Appendix "B" to SRPBS.23.003 City Files: OPA-23-0004 and ZBLA-23-0005

SUBJECT: OFFICIAL PLAN AMENDMENT, ZONING BY-LAW AMENDMENT

Municipal Address: 9712 Yonge Street

City File No.: OPA-23-0004, ZBLA-23-0005

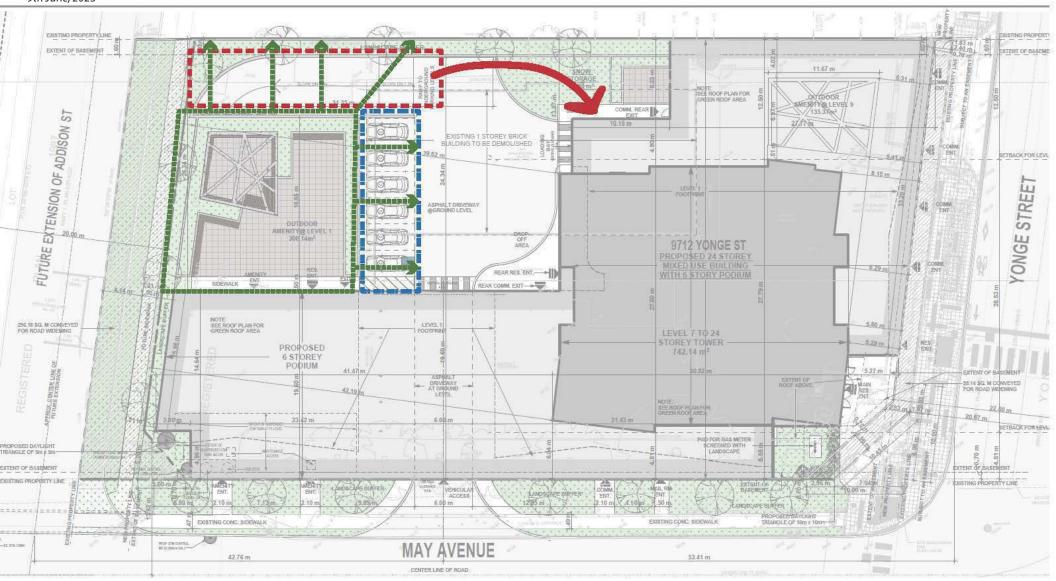
A) SITE ORGANIZATION & DESIGN				
Issue	Comments / Recommendations	Policy / UDG Ref.		
1. Surface Parking	If feasible, move the six (6) surface parking bays abutting the eastern edge of the proposed outdoor amenity area to the underground parking structure, and dedicate that land to additional at grade outdoor amenity space. (Refer to Appendix 1)	UDG 5.4.22		
2. Location of Parking Ramp	The applicant should relocate the underground parking ramp to be adjacent to the proposed loading bay (Refer to Appendix 1). This will:	UDG 6.6.2225

- ensure the integration of building servicing / loading / utility requirements;
   and
- allow for additional land dedi.
- 3. Size of Urban Open Space

Further to the points above, the applicant should consider a larger at grade outdoor amenity space through the reconfiguration of the site as noted above. (Refer to Appendix 1)

Comment A.1 - Relocate surface parking

Comment A.2 - Relocate access ramp

Comment A.3 - Integrate larger open space
